May 25, 2003

Nunavut Water Board
Box 119
Gjoa Haven, NU
X0B 1J0

Re: Polaris Mine Reclamation and Closure Plan-Meltwater Control Procedures

Disposal Location
wrt KEX Zone

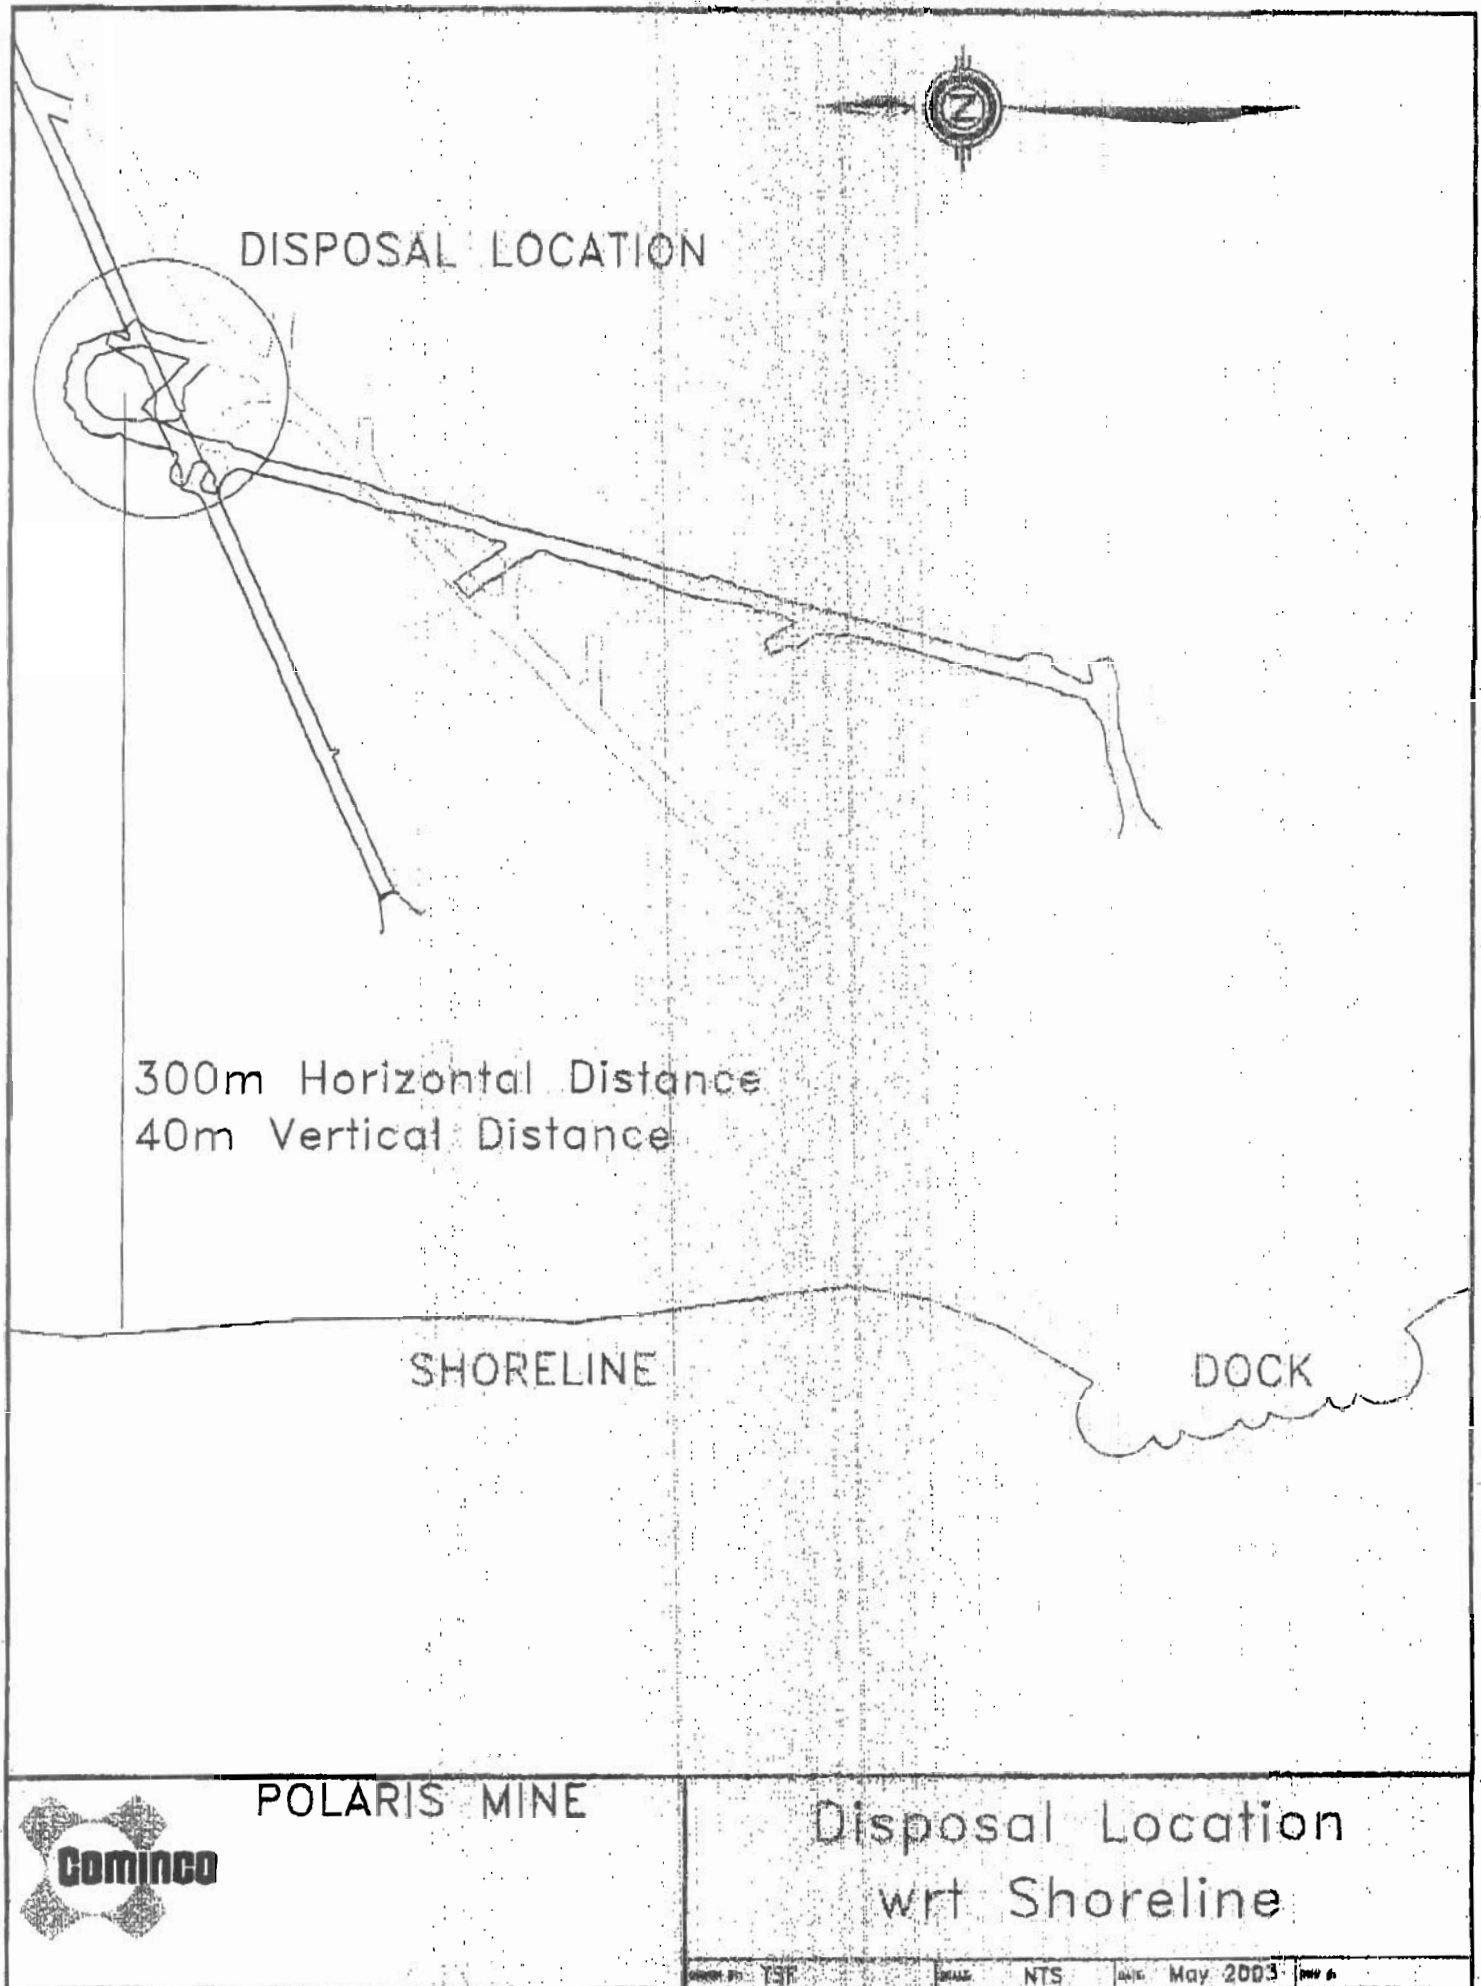
- g. Consideration of risk to area designated for disposal of hydrocarbon contaminated soils; What I the proximity of the proposed disposal chamber to the area designated for underground disposal of hydrocarbon contaminated soils?

The KEX zone, designated for receiving soils contaminated with hydrocarbons, is laterally removed from the area being recommended for melt water by 600 meters (see Drawing 'Disposal Location wrt KEX zone). Also, the KEX area is 160 meters below the disposal chamber. The straight-line distance between the two areas is 620 meters. Both zones are in cold areas of the mine, well away from the -4 C thermocline which was viewed during operations as the point where the risk of thawing precluded safe mining.

Mine Composite
wrt Shoreline & LRD

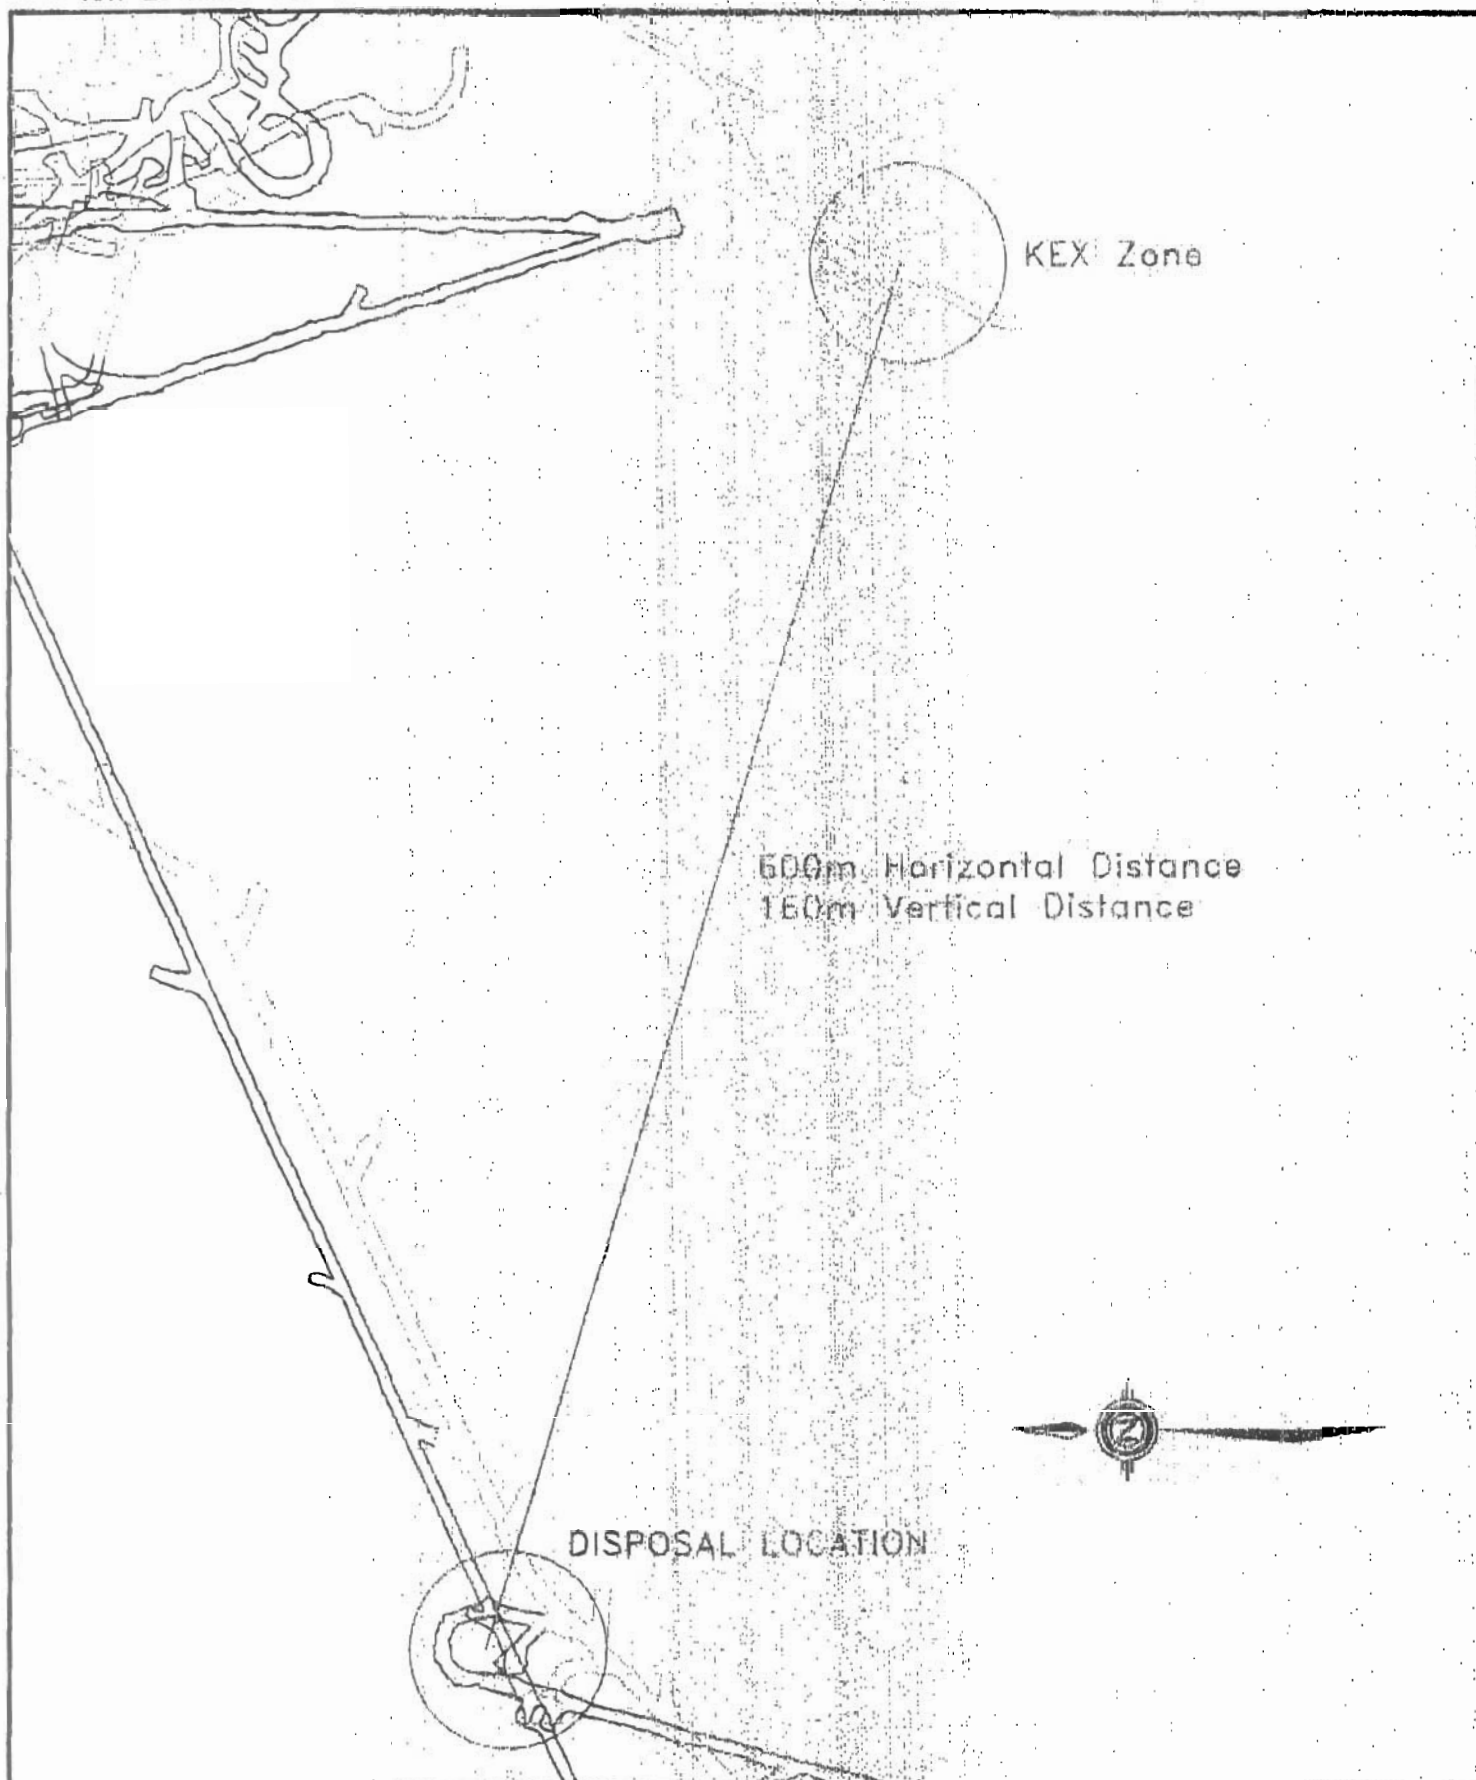
- d. Confirmation that there is no risk of thaw bulb reaching adjacent talik zones, such as the ocean floor next to mine. What is the proximity of the disposal chamber to the nearest thawed zone, such as the adjacent ocean floor?

meltwater. In the case of the West Panhandle Zone (see drawing 'Mine Composite wrt Shoreline & LRD), Cemented Rockfill was utilized. This material was heated before placement, and because it contained cement, it generated additional heat as it cured. Although it was placed in voids within 35 meters of the ocean floor, no adverse conditions were noted.

There is no risk that any thaw bulb could reach the ocean (see Drawing 'Mine Composite wrt Shoreline & LRD). Laterally the area under consideration is approximately 300 meters from the ocean, and vertically it is 40 meters below sealevel. There are no other thawed zones, as the mine workings are contained entirely within the area of continuous permafrost and permafrost extends a further 300 meters below the proposed disposal chamber. Talik zones were not encountered anywhere within the mine workings over the past 20 years of operation.
